Serial: NPD-NRC-2008-033
September 17, 2008

**SHEARON HARRIS NUCLEAR POWER PLANT, UNITS 2 AND 3
DOCKET NOS. 52-022 AND 52-023
RESPONSE TO REQUEST FOR ADDITIONAL INFORMATION LETTER NO. 007 RELATED TO
IDENTIFICATION OF POTENTIAL HAZARDS IN SITE VICINITY**

**Shearon Harris Nuclear Power Plant Units 2 and 3
Responses to NRC Request for Additional Information Letter No. 007 Related to SRP Section
02.02.01-02.02.02 for the Combined License Application, dated August 21, 2008**

FIGURE 2.2.2-202 Sheet 1 of 2

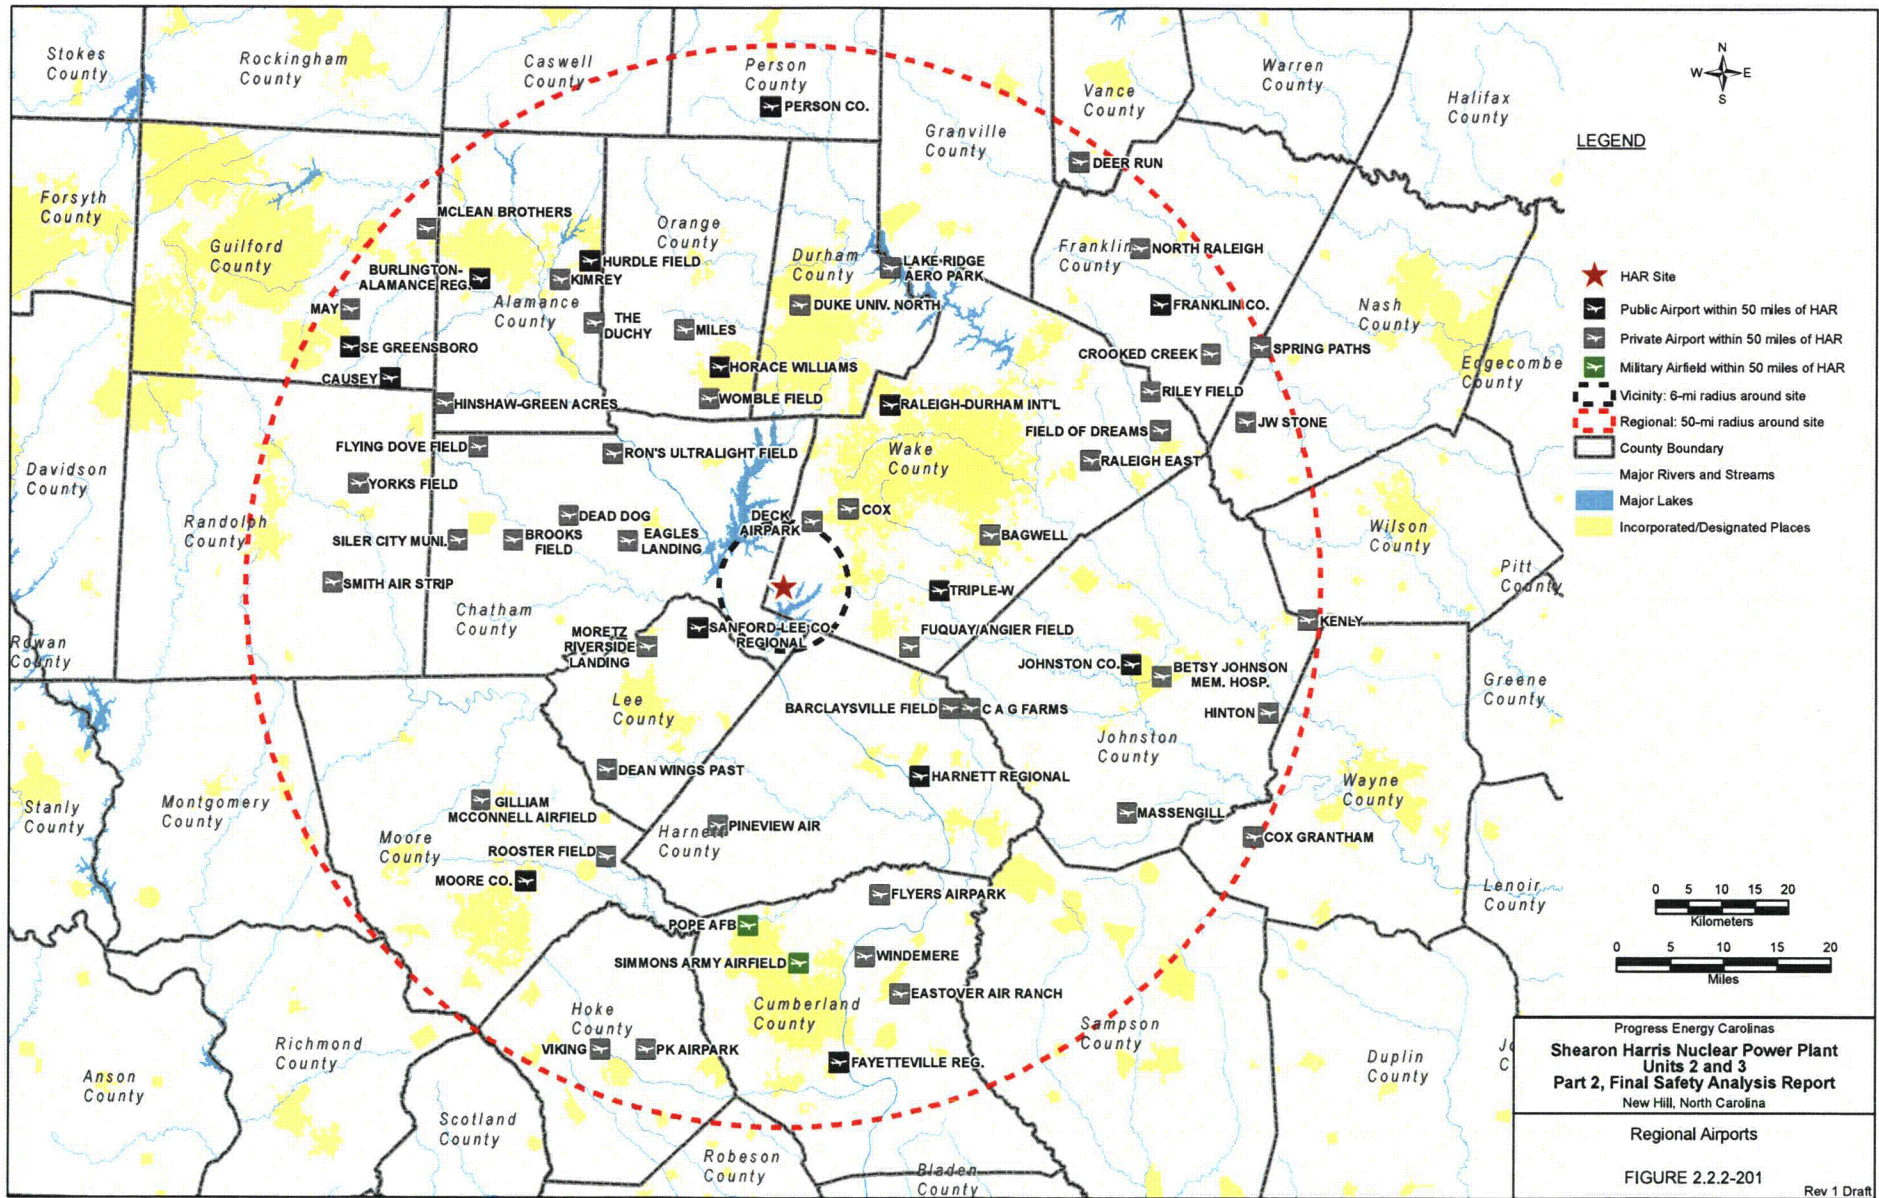
RG 1.206 provides guidance regarding the information that is needed to ensure potential hazards in the site vicinity are identified and evaluated to meet the siting criteria in 10 CFR 100.20 and 10 CFR 100.21. The FSAR Section 2.2.2.7 does not provide this information adequately to review this section. The NRC Staff's review indicates that there two Federal jet routes Airway J207 and J52- 55, whose nearest edges are well within 2 miles of HAR site. Therefore, in accordance with the acceptance criteria 3.5.1.6, the aircraft hazards associated with these jet routes should be evaluated and addressed in Section 3.5.1.6. Please evaluation, or provide justification for their exclusion.

The centerline of Airways V3-66-155, J207 and J52-55 are located 5.5, 2.6 and 3.8 miles, respectively, of the HAR site. The boundary of each these airways is 4 nautical miles from the centerline. Thus, the outer boundary of each of these airways is within 2 miles of the HAR site. Therefore, an aircraft hazards evaluation of these airways will be conducted. After the evaluation is completed, the revision to FSAR Subsection 3.5.1.6 (to be added to the FSAR in a future amendment) will be submitted to the NRC by January 30, 2009.

"The outer boundary of four airways are routed within 2 miles of the HAR site: IR718, V3-66-155, J207 and J52-55 (shown on Figure 2.2.2-202)."

2. Replace FSAR Figure 2.2.2-202, in its entirety, with the version listed under **Attachments/Enclosures** below. A second sheet has been added to Figure 2.2.2-202 that indicates the routes of Airways J207 and J52-55.
